Jetter

**Technical Information
Version Update**

August 19, 2002

**JX6-CON1 / JX6-CON+ Modifications
from Version 3.001 to Version 3.004**

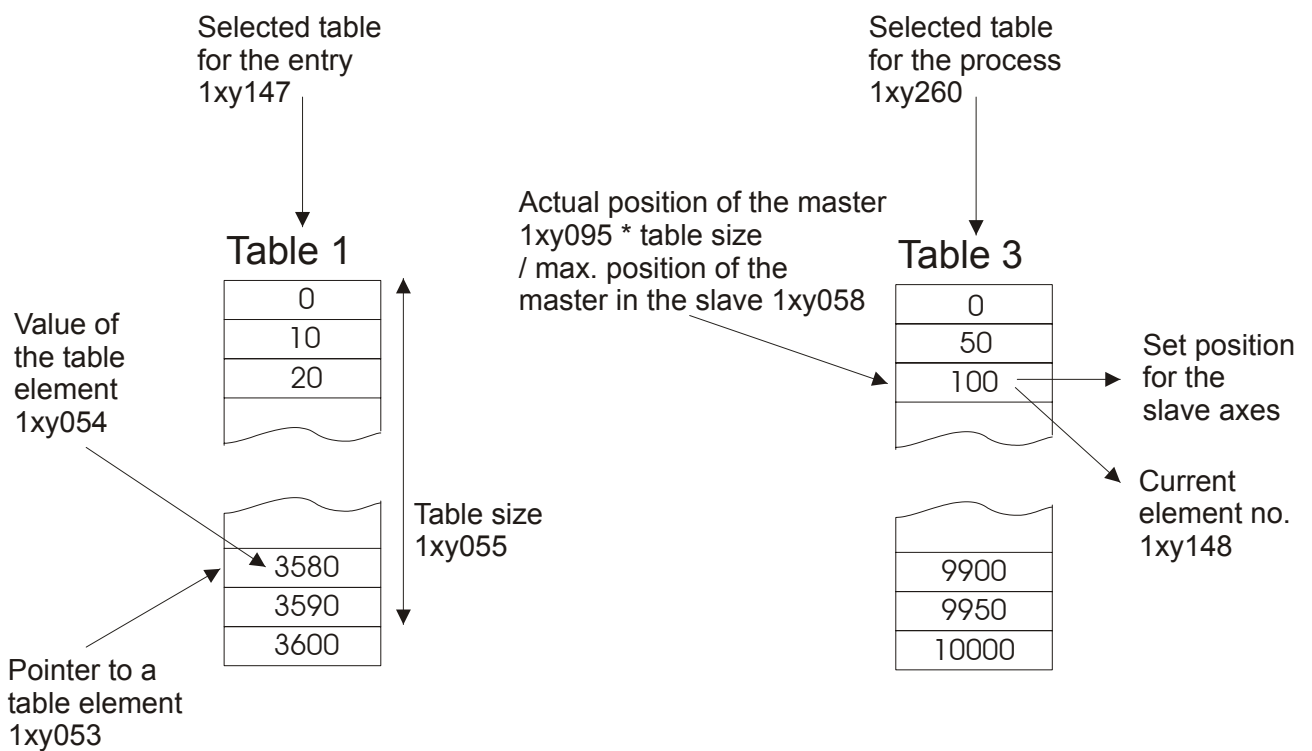
- (3.004) Starting from this version, the tables can be entered and processed separately. This means that it is possible to enter another table while a table is being processed. The new register 1xy260 serves to select the table for the process.

The following diagram illustrates the entry and process of various tables:

As in previous versions, different table sizes are allowed. As long as register 1xy260 is not written, register 1xy147 is used as selected table for the process.

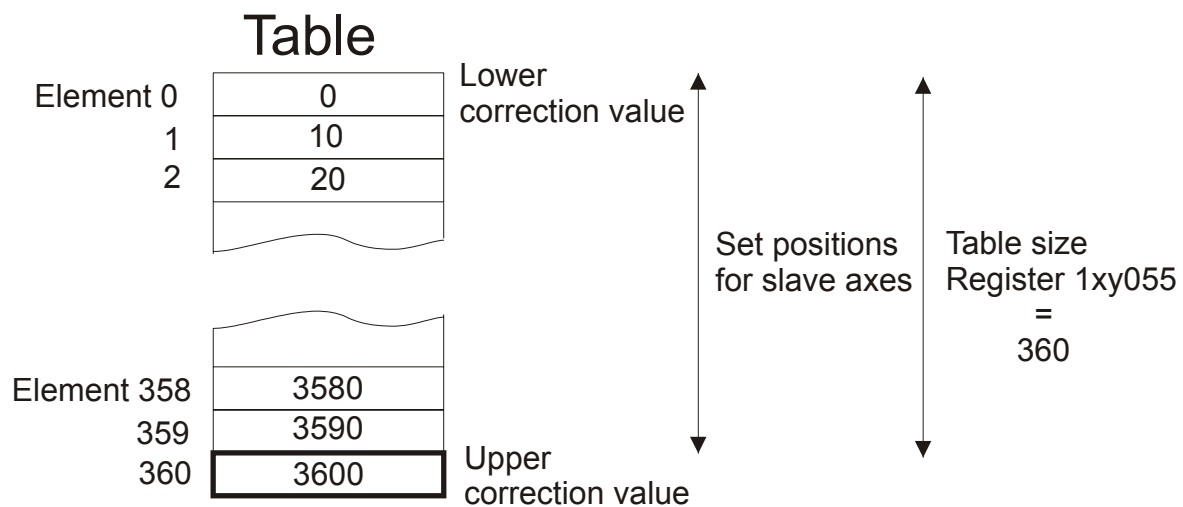
- (3.001) Using the acceleration limitation (register 60) with the follower only worked in one direction.
- (3.002) When recording the actual position in JetSym or Sympas oscilloscope mode, the values might have been incorrect.
- (3.003) Starting from version 2.900, an error might occur when creating a table if a table was written before using a too extensive table pointer.
- (3.004) Starting from version 2.900, the correction value during table mode overflow applied to the last table element. Starting from this version, the correction value must be entered again as additional element:

The correction value in case of table overflow is calculated as follows:

Correction value

= Value of the table element (register 1xy055) – value of the table element (0)
 = 3600 increments – 0 increments = 3600 increments
